April 24, 2015
0106967-00002

Re: Paesano Realty Trust – 123 Waterhouse Road, Bourne
Response to Water Resources Discussions

Paesano Realty Trust
Planting Plan

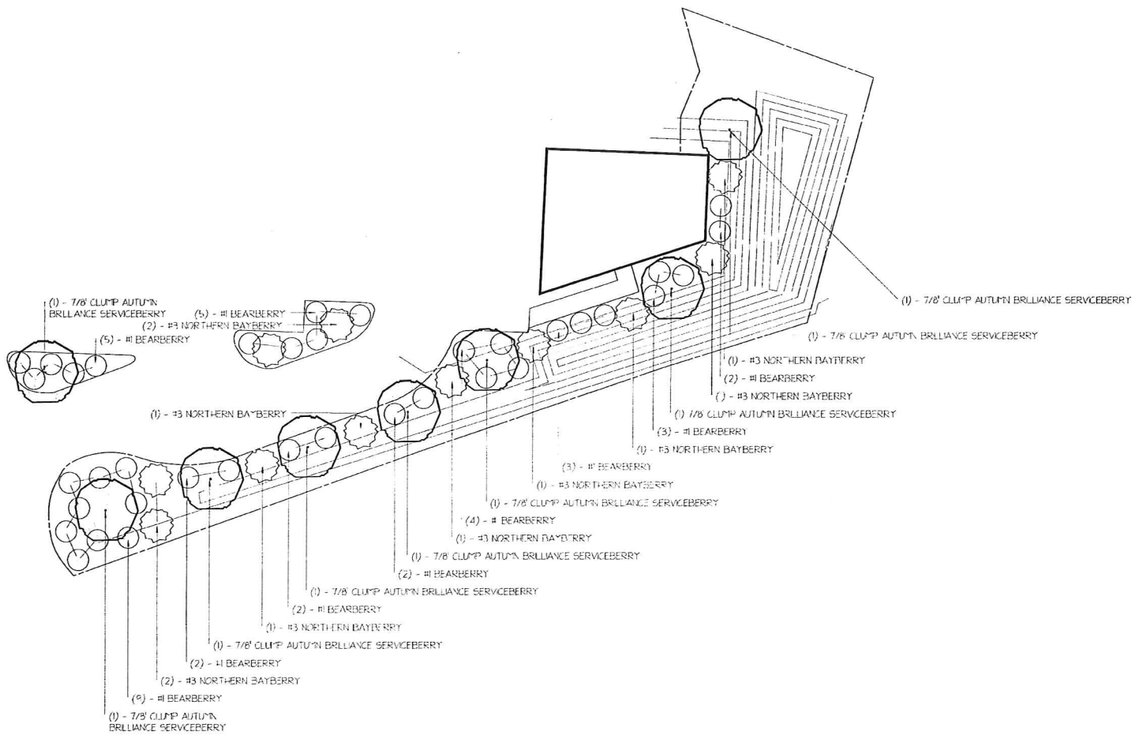
With reference to storm-water, I enclose revised drainage plans for the proposed work area. Based on our meeting with Scott Michaud, the plans have been developed to incorporate low impact design storm-water features, including grass swales to accommodate all the storm-water for the proposed new parking/building area. We also enclose updated landscape plans showing the proposed plantings in and around the proposed swales.

DRAINAGE DETAIL SHEET

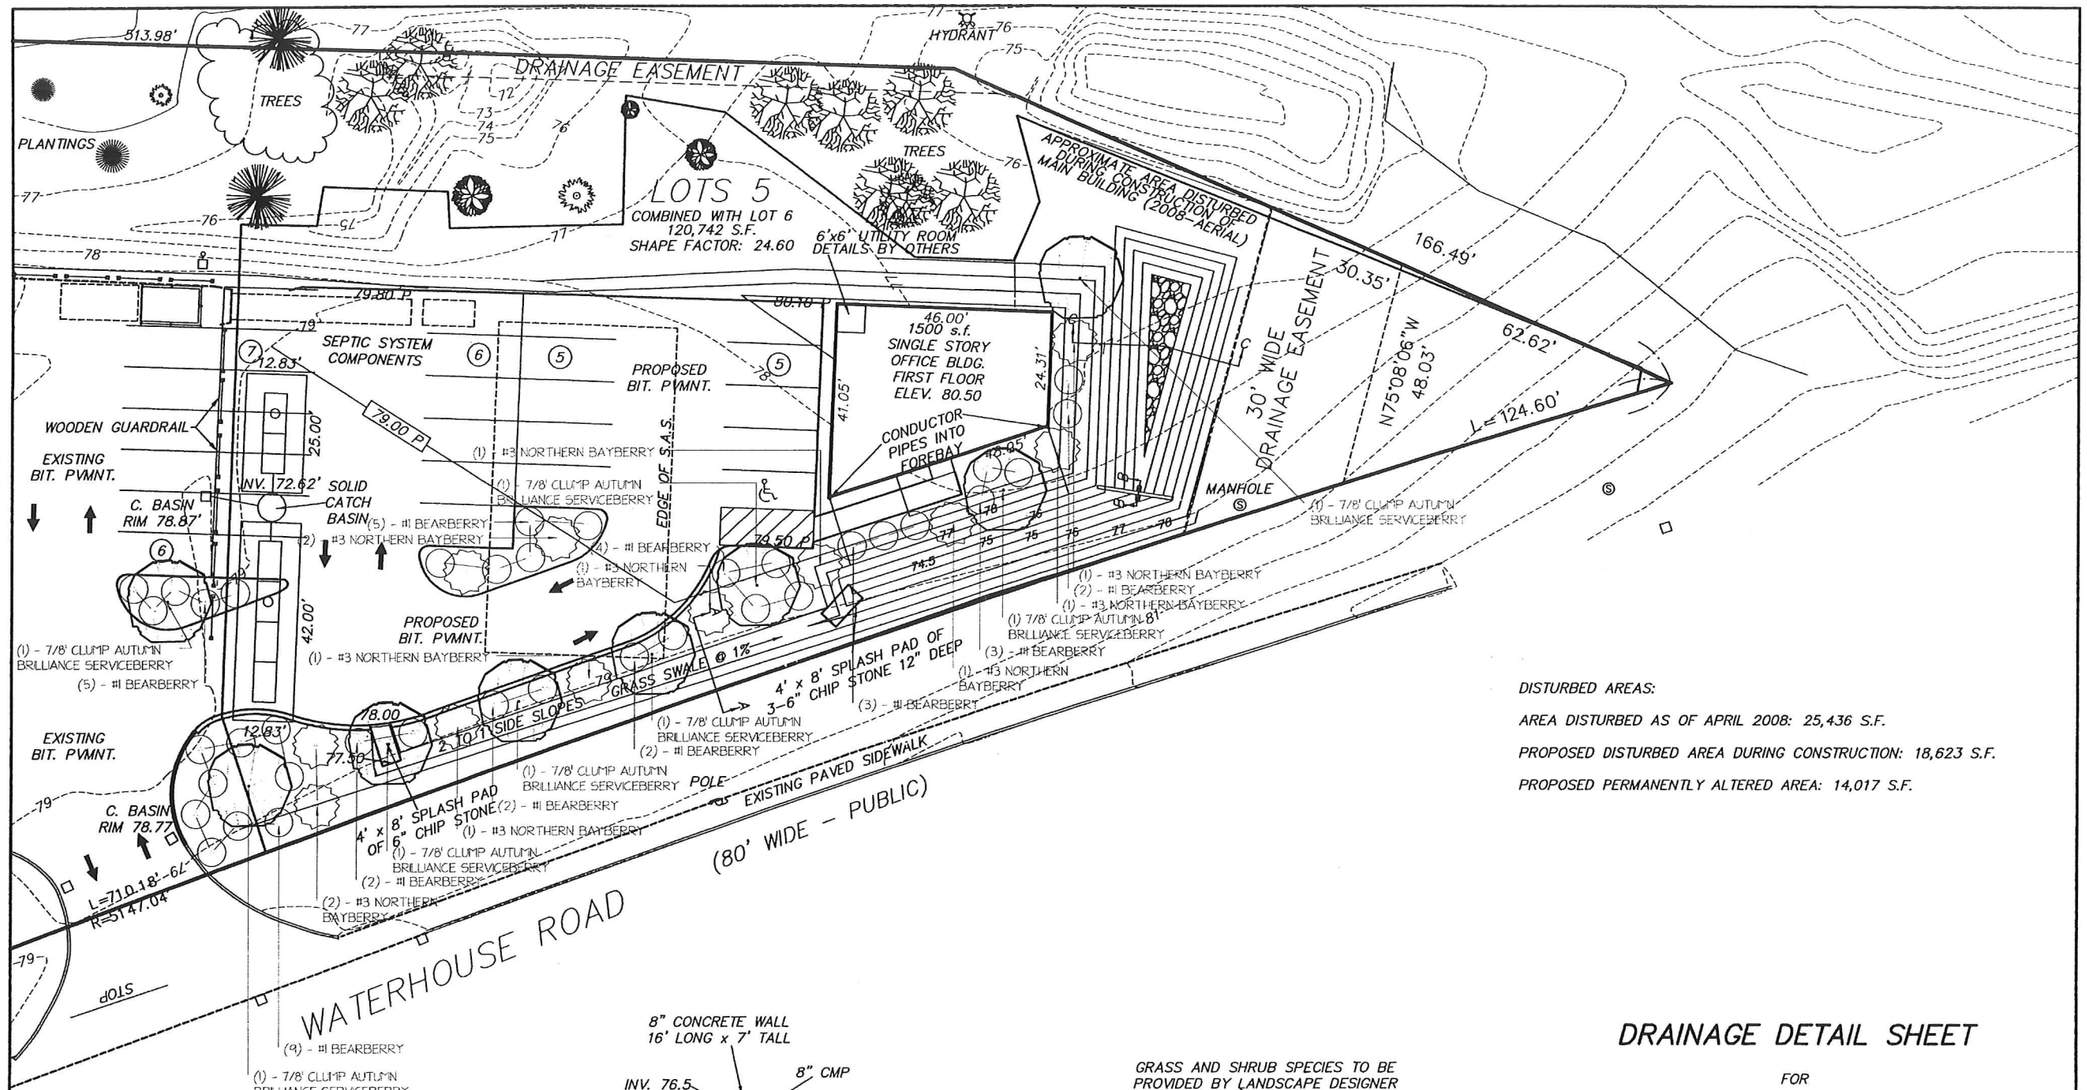
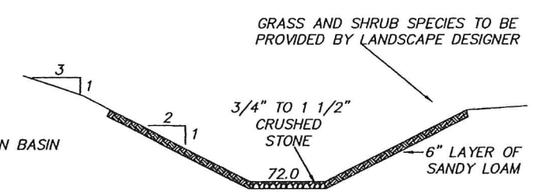
As the plans depict, the proposed development work will comply with the storm-water requirements of the 2002 RPP by incorporating low impact design measures. The civil engineer looked closely at various options to try to convert the existing structured storm-water system for the existing development to a low impact design. As you will recall, the current storm-water system was fully designed and permitted and the building constructed prior to the CCC review of the existing development. Because of the existing grades, elevations and connections with the street, the engineer has concluded that the existing storm-water system cannot be converted to a low impact design. It is not a matter of cost, but rather, is a result of the property conditions. In that the storm-water generated by the proposed construction areas will be managed with grass swales, we believe that this design meets the intent of the prior decision and, to the extent necessary, request a modification of the decision to approve the proposed storm-water design plans.
